Anti Back Slouch Reminder Electrical Schematic Revision Log:

Revision 1 (November 18, 2023)

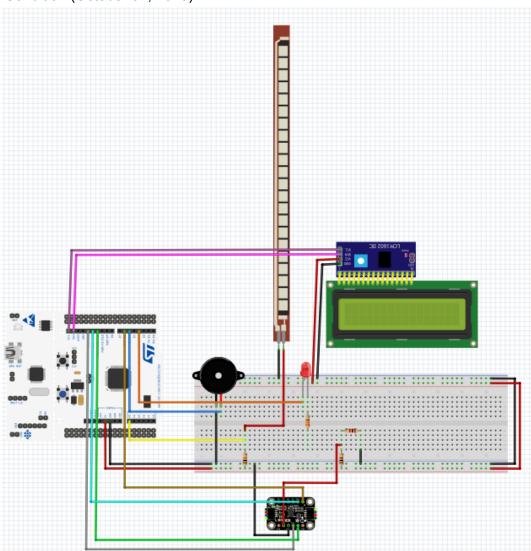
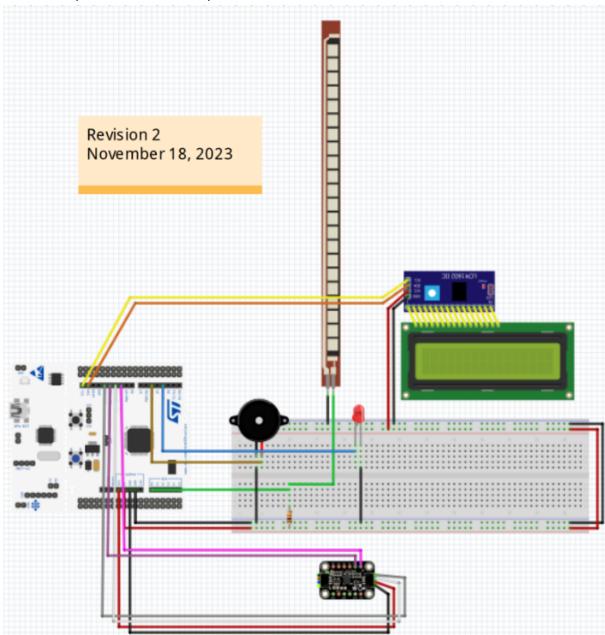
- Altered the connections with the accelerometer port to use a purchased cord to connect Vin, GND, SCL, and SDA to the microcontroller rather than the soldered ports (the microcontroller was overheating, likely due to faulty solder).
- Removed the voltage divider and connected Vin straight to the 3v3 port on the microcontroller.
- Corrected a mistake on the initial revision: Cs pin (accelerometer) was moved from D4 to CS (microcontroller).

- Inserted a 2k ohm resistor with the buzzer to reduce the volume
- Abandoned a separate LED OUTPUT pin and used the same voltage provided to the buzzer for the LED.
- Included a 1.2k ohm resistor to ensure that the LED is operating safely.

Initial Condition (October 31, 2023)

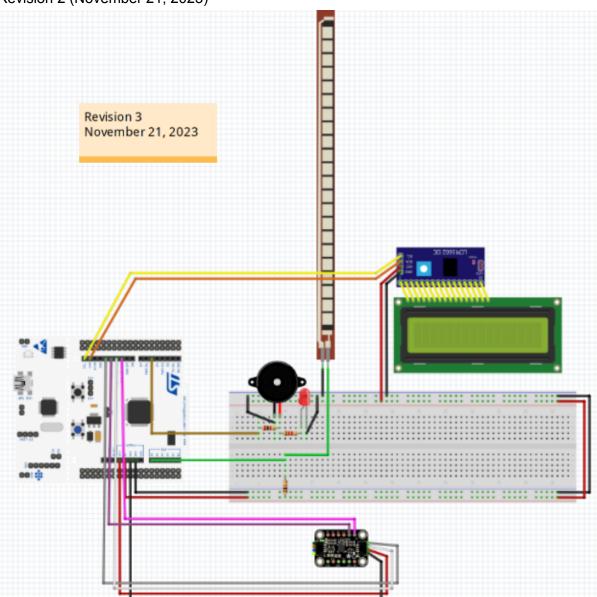
Created a schematic using Fritzing to simulate the connection between our input and output devices.
